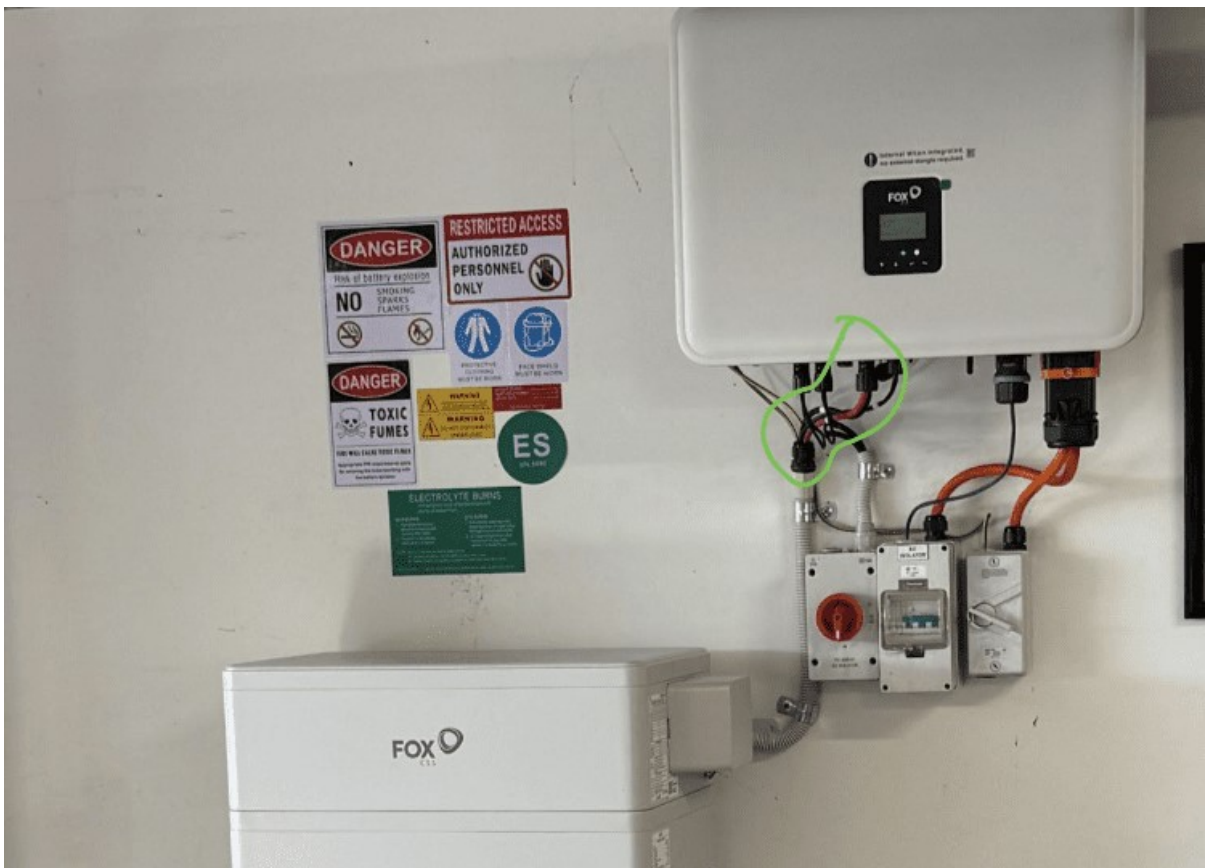
Unprotected battery cables from the battery to the inverter. Not even close to compliant.

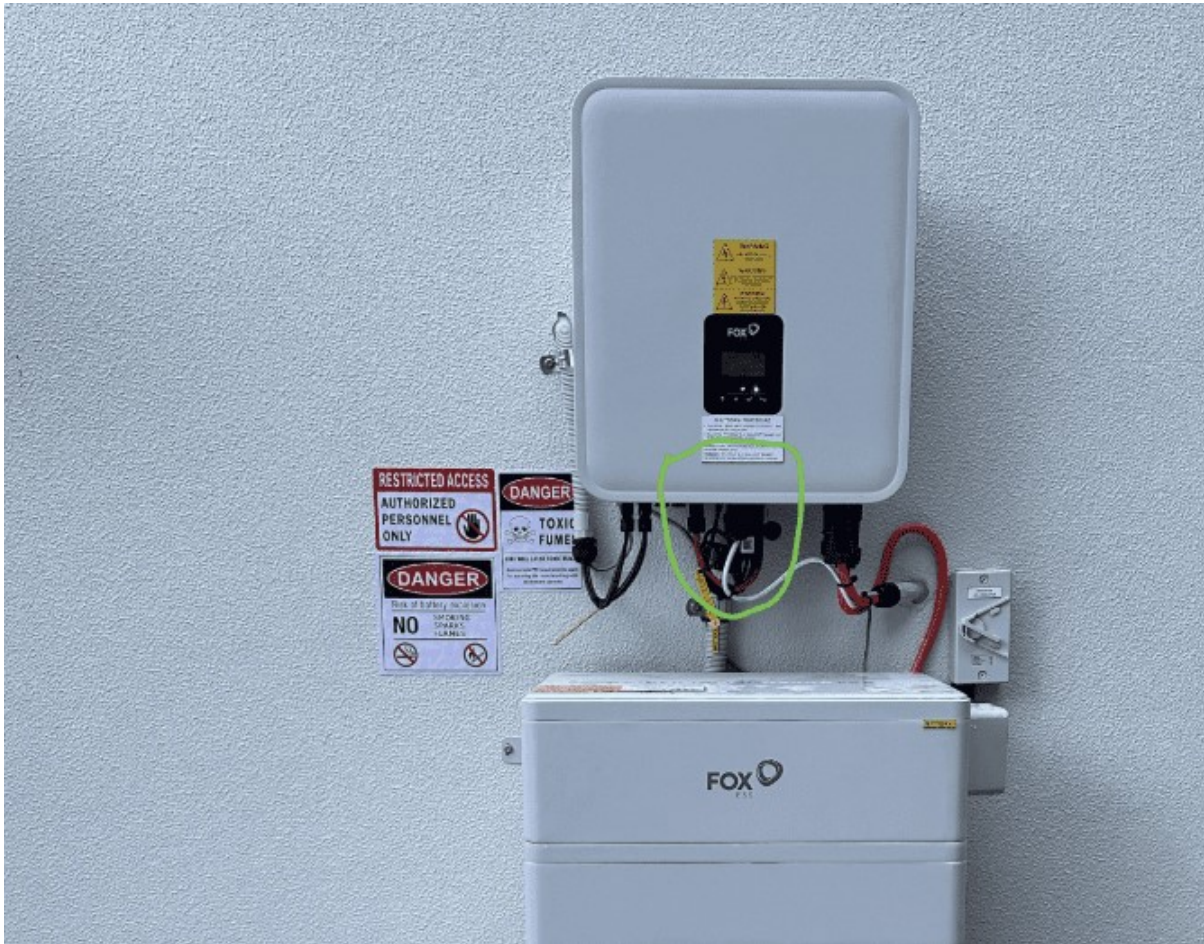
Not compliant – battery DC cable is visible. Unlike solar DC no exposed battery DC cable is allowed. Don't get me started on the stickers...

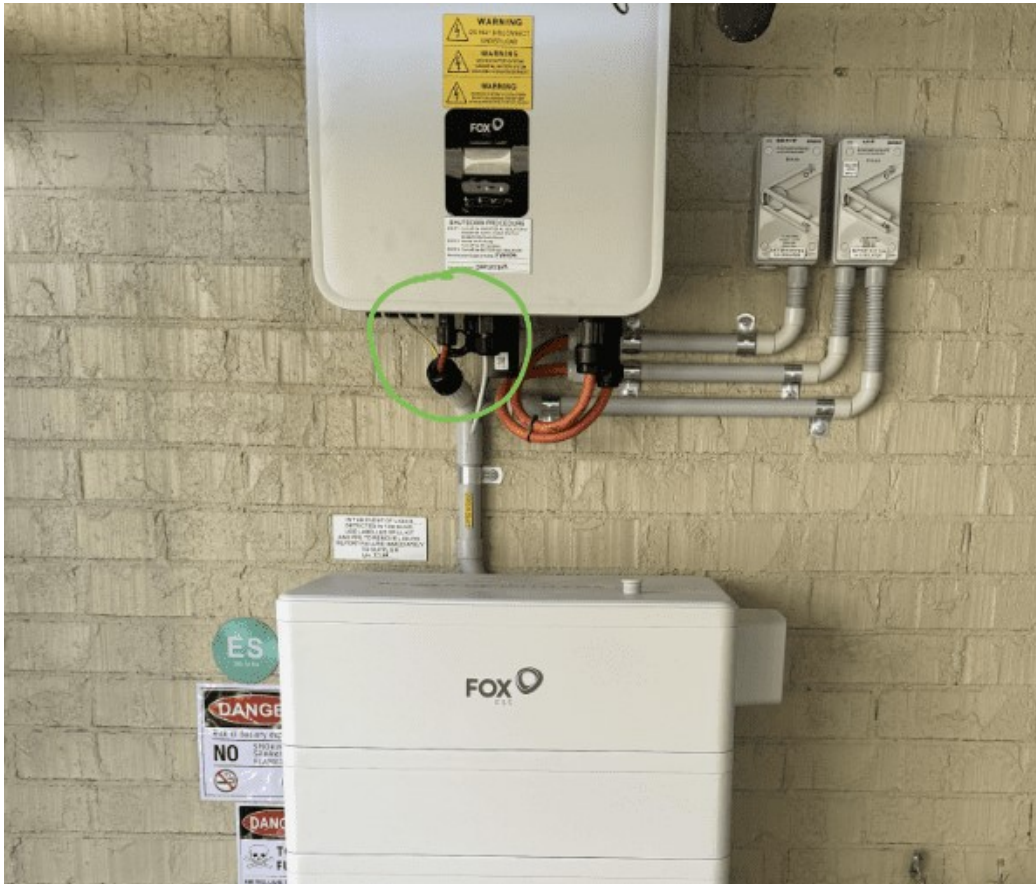
Does not comply
